PLANNING COMMISSION
DATE: 11/14/2016
AGENDA ITEM: 5A – PUBLIC HEARING
CASE # 2016-40

ITEM: Wildflower at Lake Elmo 2nd Addition Final Plat and Final PUD Plans
SUBMITTED BY: Stephen Wensman, Planning Director
REVIEWED BY: Emily Becker, City Planner
Jack Griffin, City Engineer

PLANNING COMMISSION
DATE: 10/10/2016
AGENDA ITEM: 4B – PUBLIC HEARING
CASE # 2016-40

Figure 3

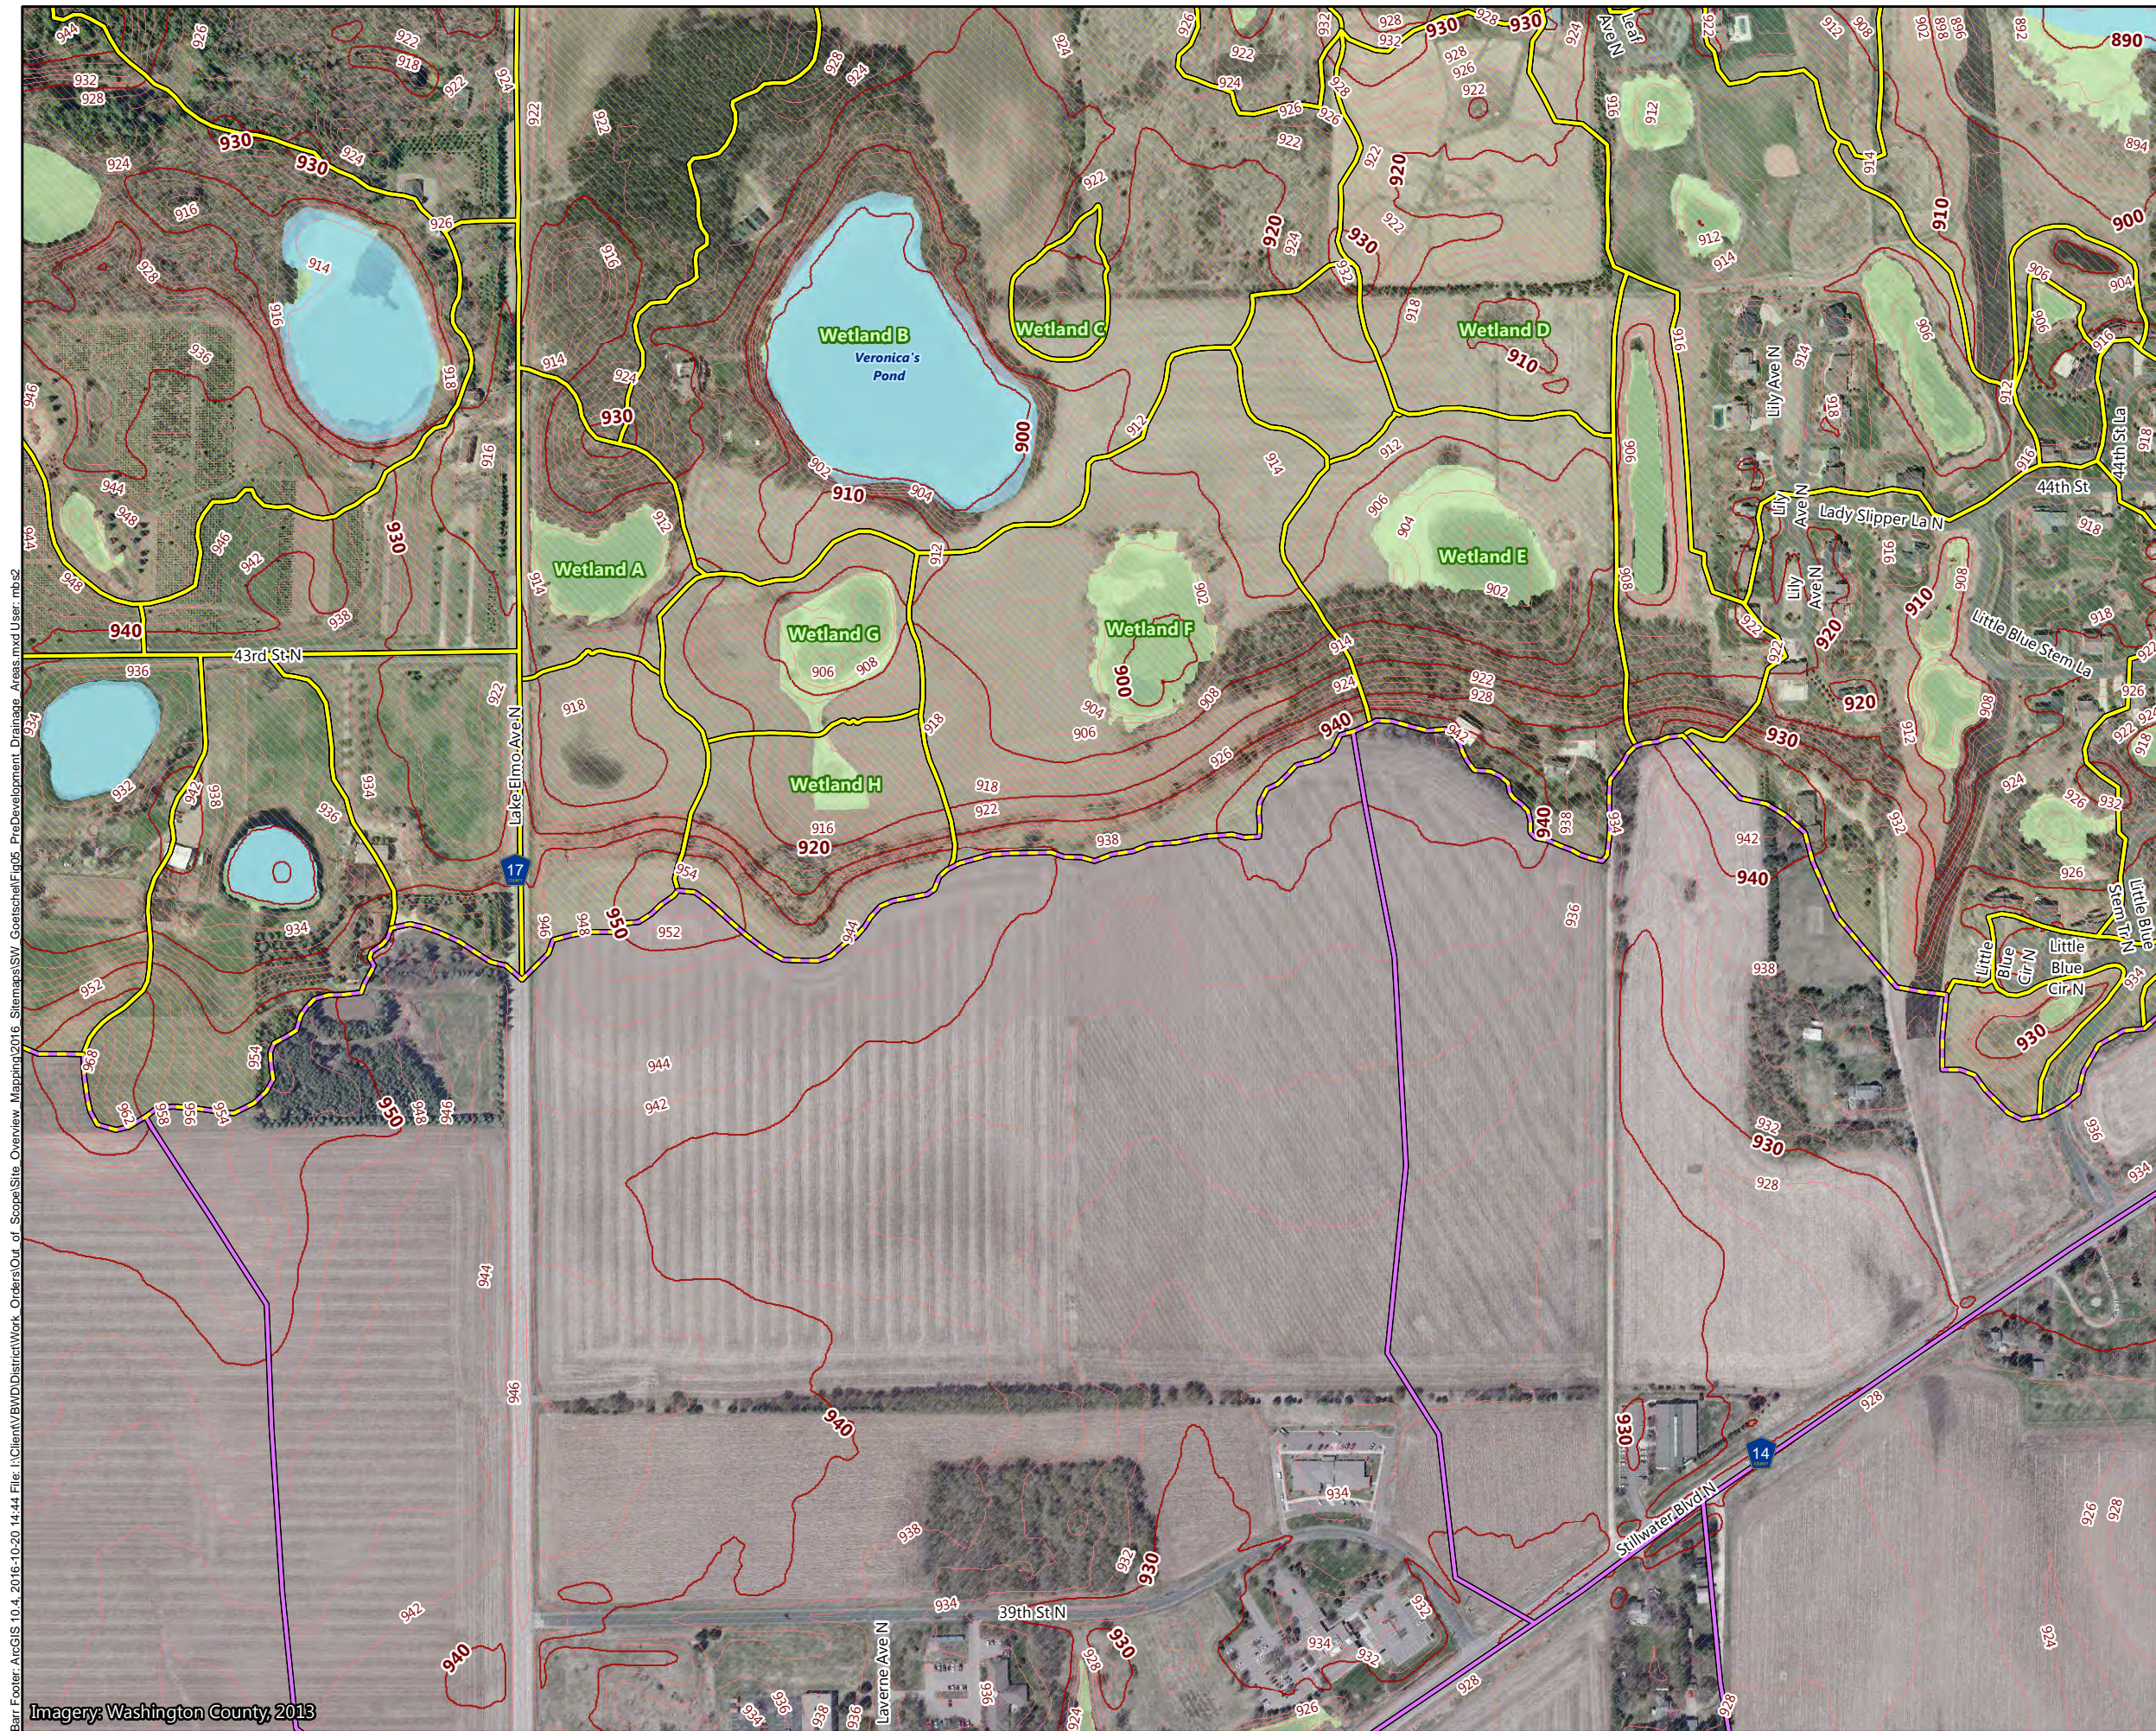
The drainage area to Wetland A (see Figure 3) was reduced with development. Within the Village Preserve site, 0.6 acres of the predeveloped 1.6-acre drainage area was diverted from flowing north into Wetland A. Runoff from the remaining 1 acre (38% impervious) in the northwest corner of Village Preserve drains to an infiltration basin with a capacity of 36,800 cubic feet (Infiltration Basin 1, see Figure 3). Soils investigations prior to construction of this basin indicated infiltration rates exceeded 20 inches per hour. It was expected to drain dry within 48 hours of rainstorms with an infiltration rate of at least 2 inches per hour. Basin overflows were anticipated only during storms significantly greater than the 100-year 24-hour design storm (7.3 inches).

Wetland H and G (see Figure 3) receive runoff from the Arbor Glen Senior Living Facility and Village Preserve sites. Before development, runoff from the Arbor Glen Senior Living Facility and Village Preserve generally drained southeast and eventually to Downs Lake. Once complete, part of the Arbor Glen Senior Living site and all of the Village Preserve site will drain north to the Goetschel Pond watershed. The VBWD allowed this diversion because soils investigations and computer modeling showed that the diversion would not increase the 100-year flood level of the local lowlands or Goetschel Pond. Figures 5 and 6 show the pre- and post-development drainage areas.
